Reliability Analysis Update

Transmission Expansion Advisory
Committee

February 11, 2016

Project Scope Change to Existing Project: B1794

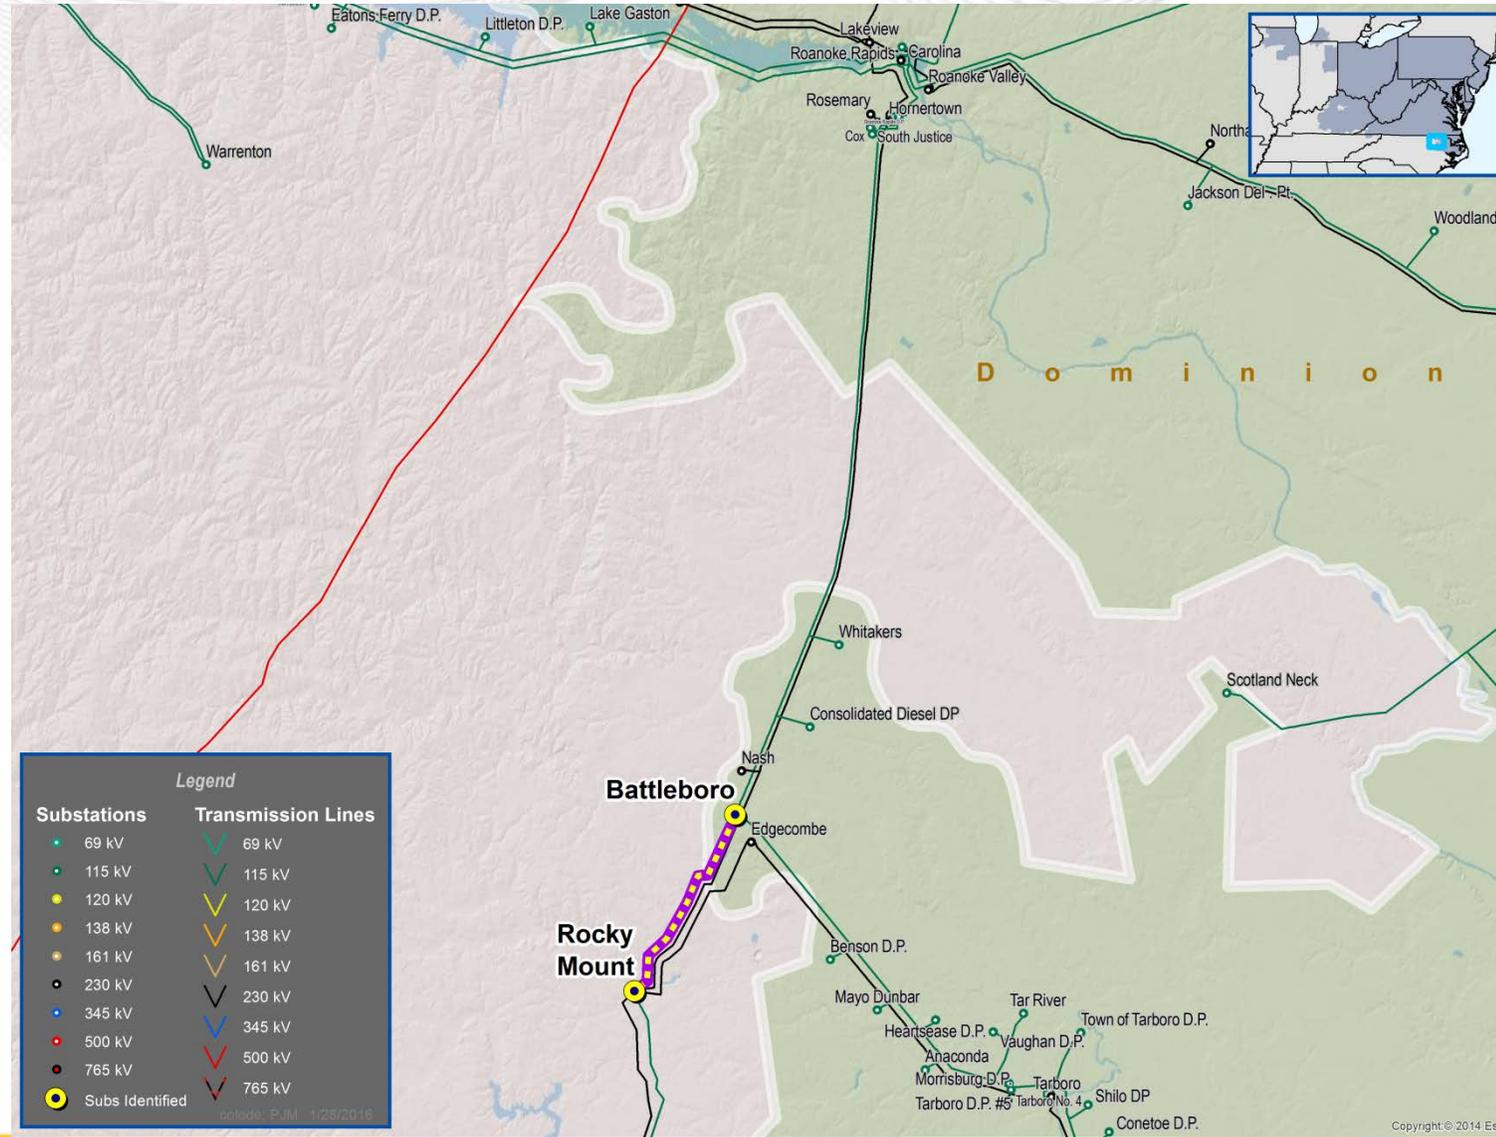
Problem: N-1 Thermal Violation

- Overload of Rocky Mt - Battleboro 115kV for the loss of Battleboro – Carolina 115kV

Previous Scope:

- Build a new substation near Edgecombe NUG to be called Morning Star Substation with a 230-115kV Tx, 4-230kV breakers in a breaker and half scheme, 3-115kV breakers in a ring. Re-configure Lines 80, 229 and 2058 to terminate into Morning Star Substation.

Reason for Revision

- Original land acquisition was no longer available therefore, a new site was pursued just west of Edgecombe NUG near Hathaway Road (B1794)

New Scope:

- Build a new switching station west of Edgecombe NUG to be called Hathaway Switching Station (previously called Morning Star) with a 230-115kV Tx, 5-230kV breakers in a breaker and half scheme, 4-115kV breakers in a ring. Re-configure Battleboro – Benson 115kV, Nash – Hornertown 230kV, and Edgecombe Nug – Rocky Mt. 230V to terminate into Hathaway Substation (B1794)

Project Cost Change to Existing Project: B2186

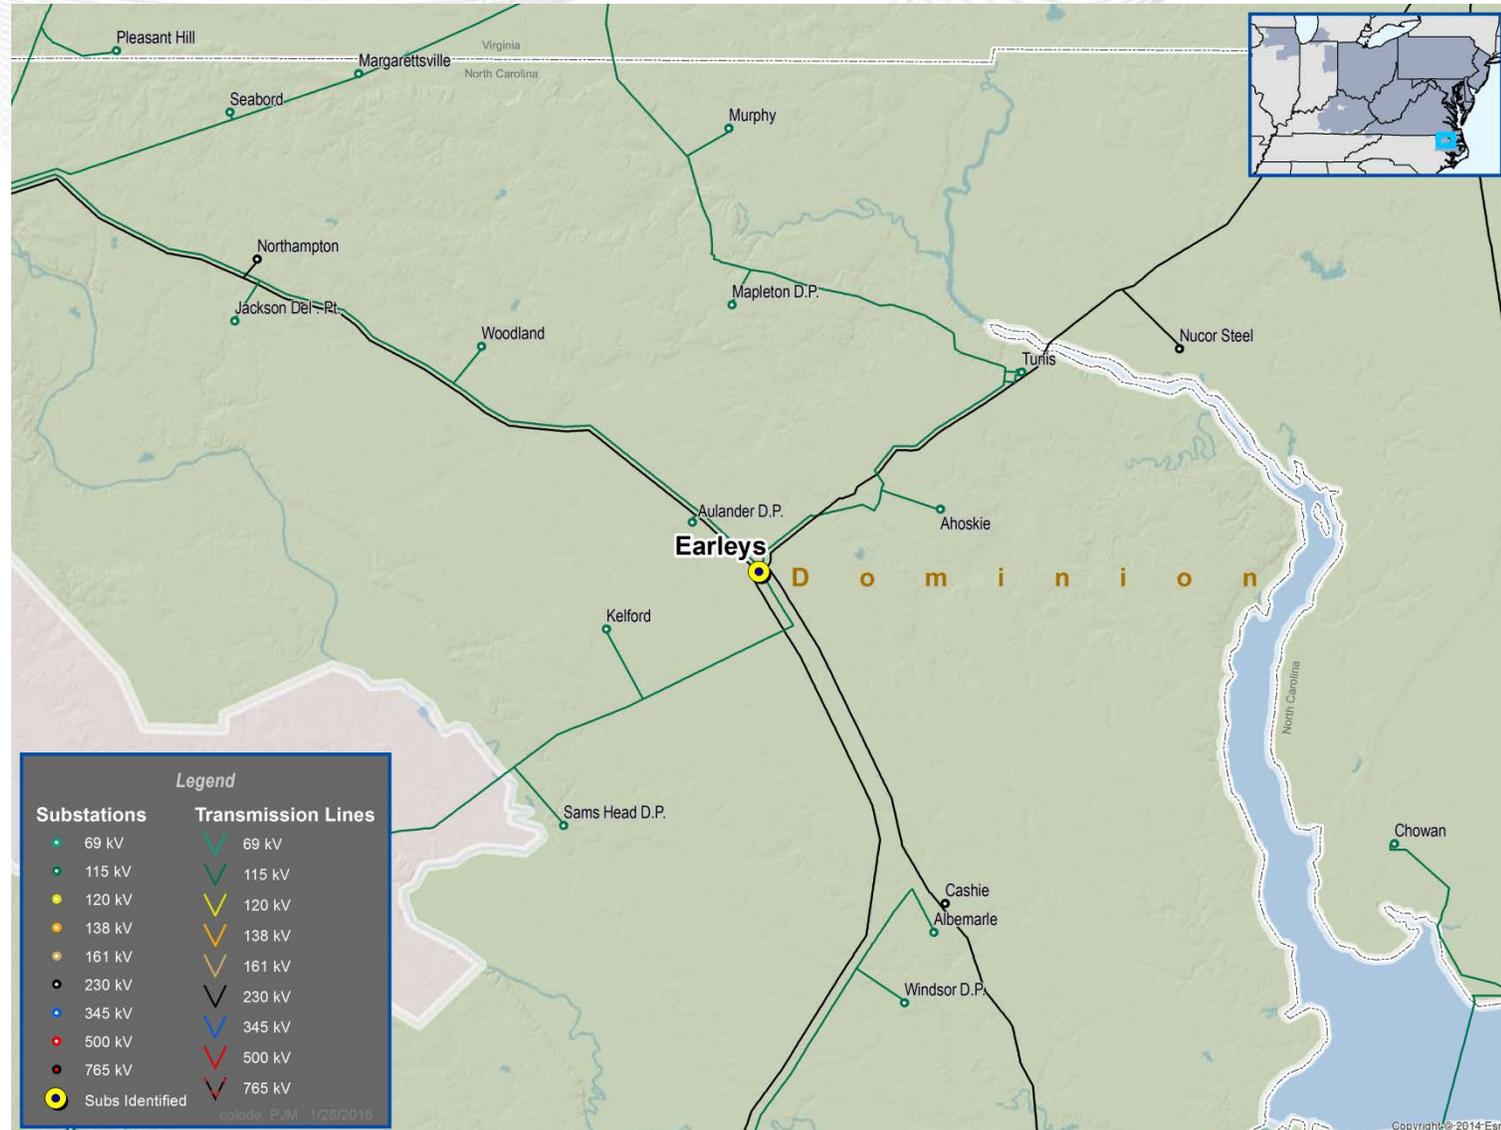
Problem: N-1-1 Thermal Violation

- The loss of Carolina – Earleys 115 kV and the Earleys 230-115kV transformer overloads Boykins – Tunis 115kV

Reason for Cost Change:

- Cost changes reflect increase in construction costs due to equipment being relocated to allow for installation of the required 2nd transformer.

Original Estimated Cost: \$6.0 M

Revised Estimated Cost: \$ 11.5 M
